ZEE Systems, Inc.

SERVICE LETTER 47-003-2

1.0 EFFECTIVITY: All SZ47-003-1A and SZ47-003-2A Blower Assemblies that have incorporated SL47-003K.

2.0 PURPOSE: To provide instructions to return the Blower Assembly to the original configuration.

FIG. 1

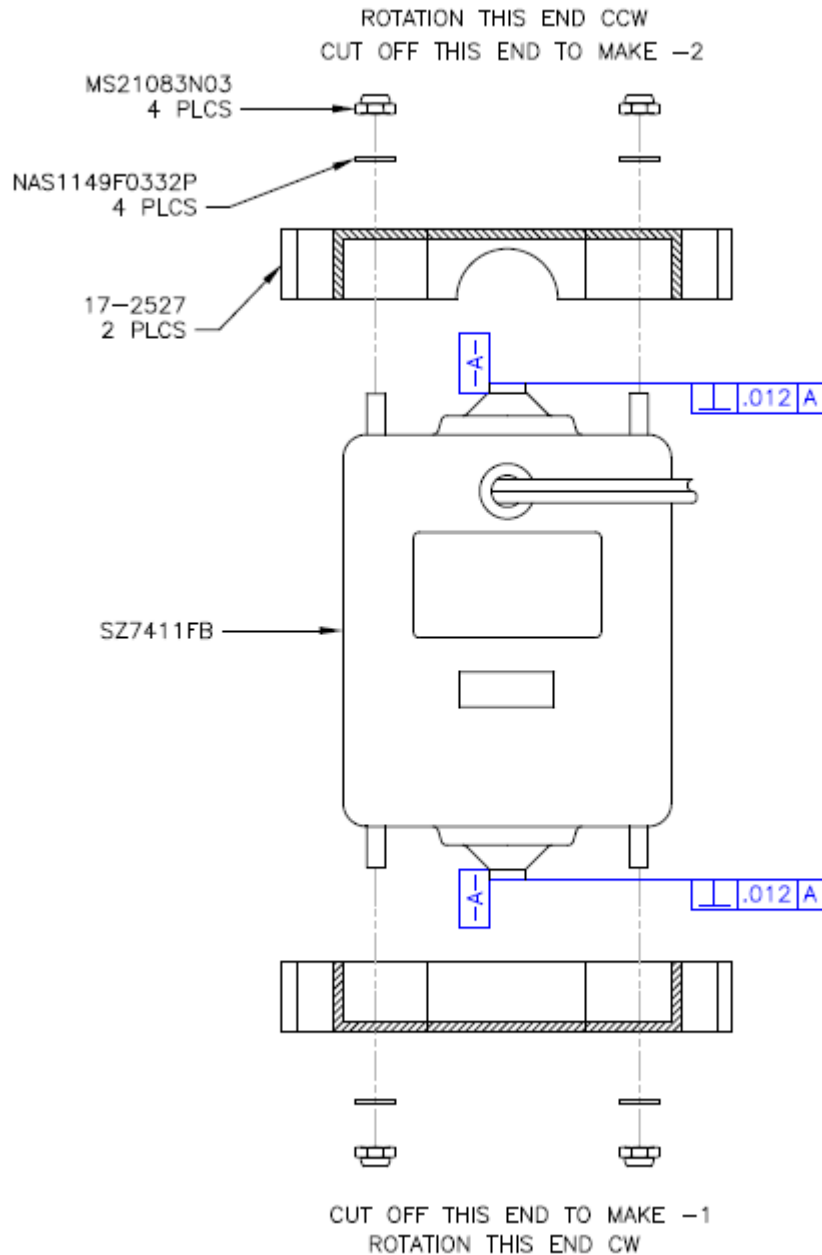
9.4 After the opposite shaft has been removed place 1 each Motor Support 17-2687 on each end of the motor. Secure with one NAS1149F0332P Flat Washer and one MS21083N3 Lock Nut on each of the four studs through the two 17-2687 Motor Supports. See FIG 1.

FIG. 2

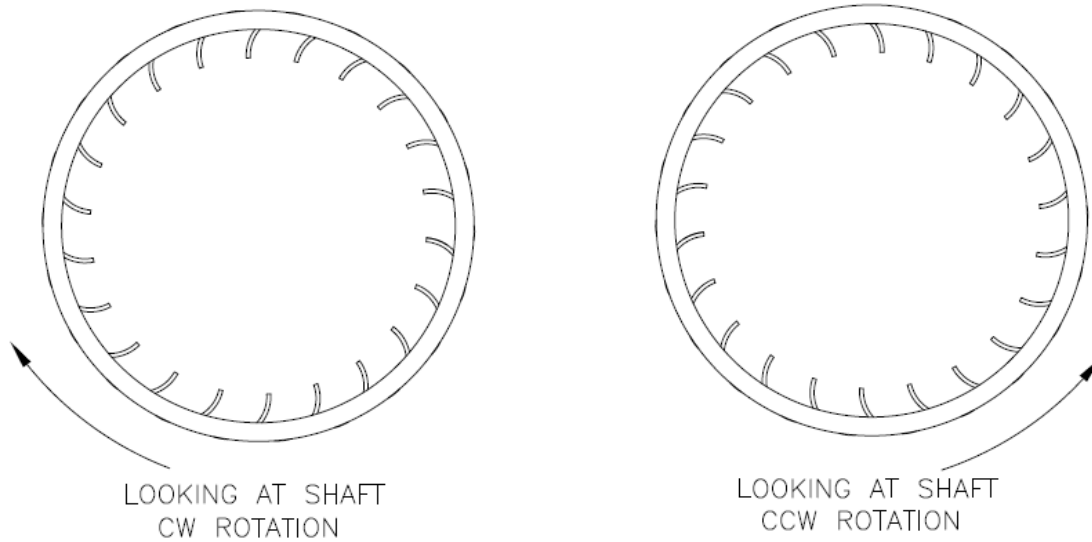
9.5 The 16-2527 Blower Wheel rotation must match the rotation of the shaft. See FIG. 2 Push the Blower Wheel onto the shaft until you have the same spacing as the old wheel. Fit the motor and wheel into the Lower Housing (17-2642). Adjust the position of the wheel on the shaft so it does not touch the housing on either side. Adjust the spacing of the wheel on the shaft as necessary. When the proper spacing is achieved attach the 916-901 Clip on the Blower Wheel.
